## SERVICE INFORMATION BULLETIN

**TITLE:** McLaren P1™ Exhaust Muffler Bracket Replacement

**DOCUMENT NUMBER:** 12 H 001

**AFFECTED VEHICLES:** McLaren P1™

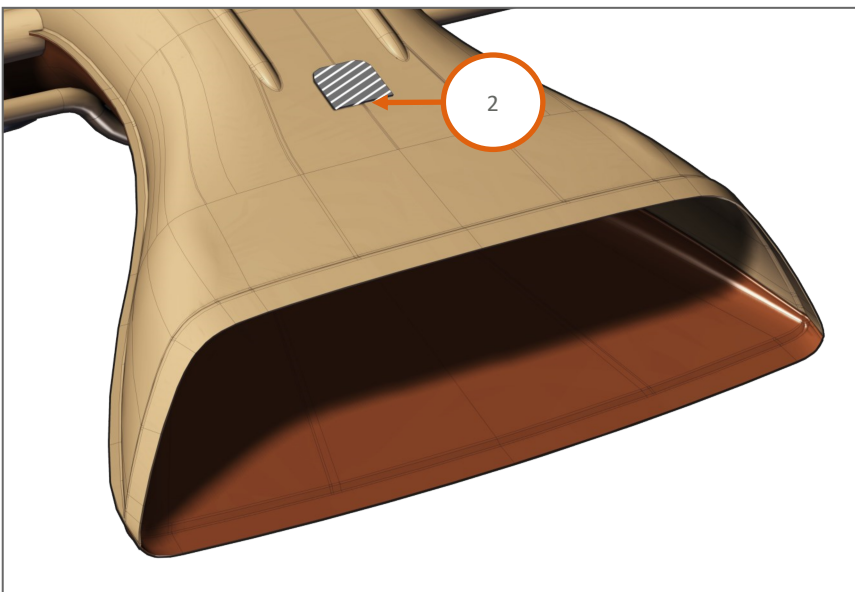
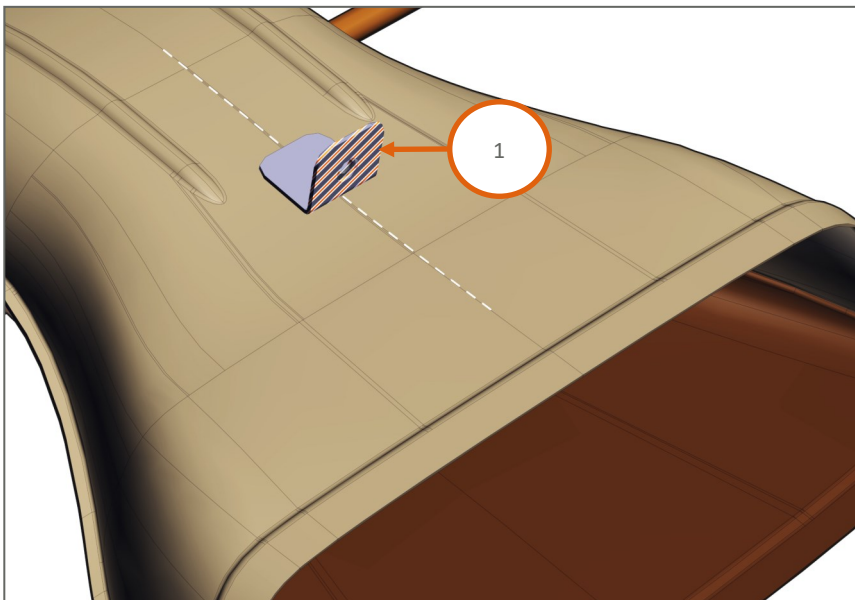
**SITUATION:** McLaren Automotive have identified that the lower exhaust muffler trim bracket might fatigue and fail, causing the trim to rattle against the exhaust muffler. As a result, the original welded bracket has to be replaced with a new bracket which is bolted to the muffler.

4. In this scenario the vertical section (1) of the bracket is detached from the rest of the bracket. This section is still attached to the muffler and has to be removed and scrapped. Use an Angle Grinder to flatten the edge off the horizontal section (2) of the bracket. Once this is completed proceed to Step 6.

5. In this scenario the complete bracket is intact. First use an Angle Grinder with a cutting disc to cut and remove the vertical section (1). Then use a Angle Grinder to flatten the cut section (2). Once this is completed proceed to Step 6.

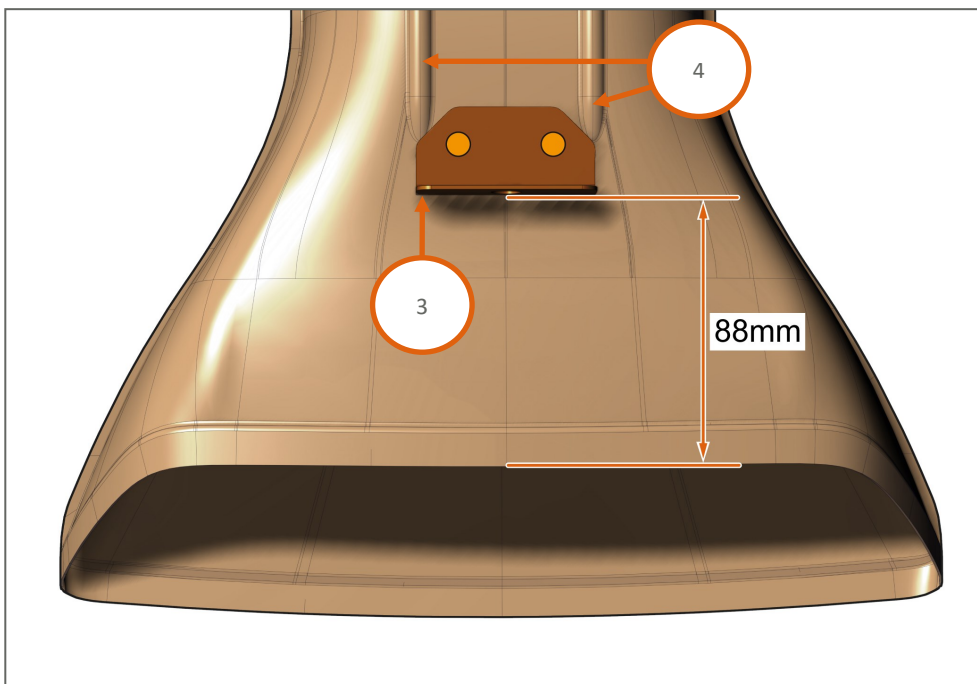
6. Place the new bracket 12HA001MP (3) in the position shown in the picture below. Ensure the bracket is located in the middle of the two strengthening ribs (4) and 88mm from the end of the muffler.
7. With a permanent marker pen mark the centre of the two holes to the muffler.
8. Remove the bracket and use a Centre Punch Tool to mark the centre of the pen marks that were created at Step 7.
9. Drill two pilot holes.

**Care Point:** Do not attempt to drill the 6.5mm diameter holes with the same size drill bit as this will damage the drill bit and the part. Start with a 2.5mm diameter drill bit, then 4.5mm and finish with 6.5mm drill bit to achieve the 6.5mm holes.

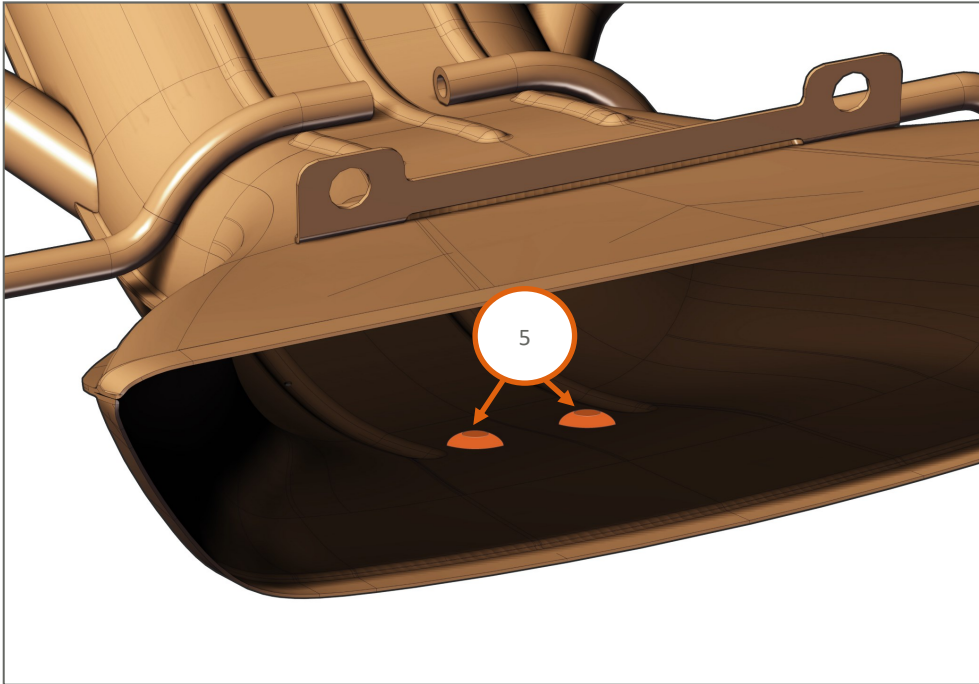
10. Drill two holes of 6.5mm diameter.

11. Insert new fixing bolts (00RA310) through from the inside of the exhaust muffler (5).

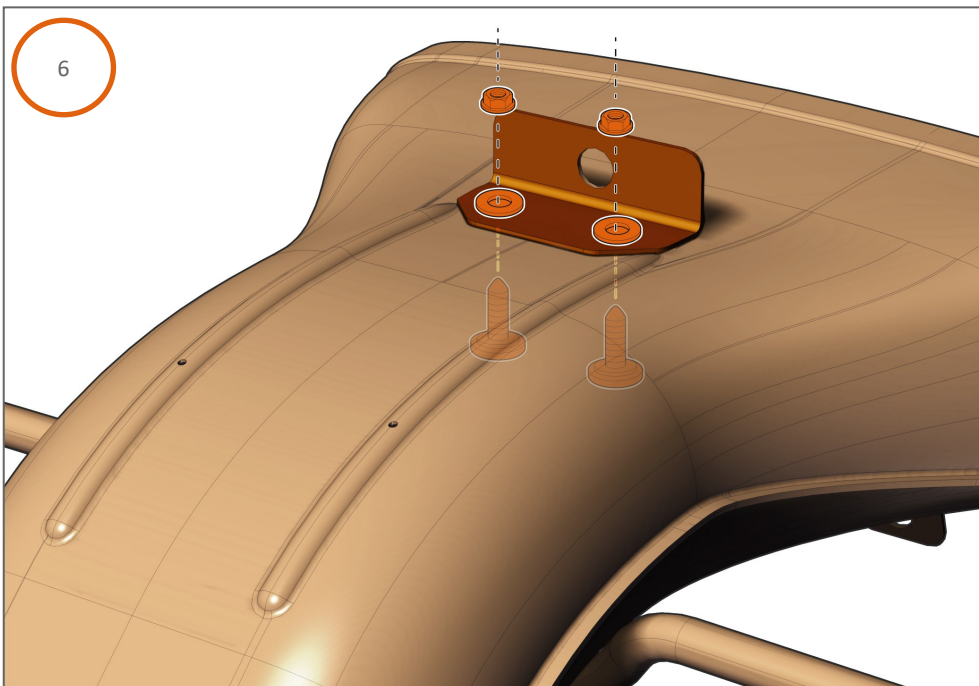
12. Attach the new bracket with washers (00RC077) and nuts (00RA511) (6) and torque to 8Nm.
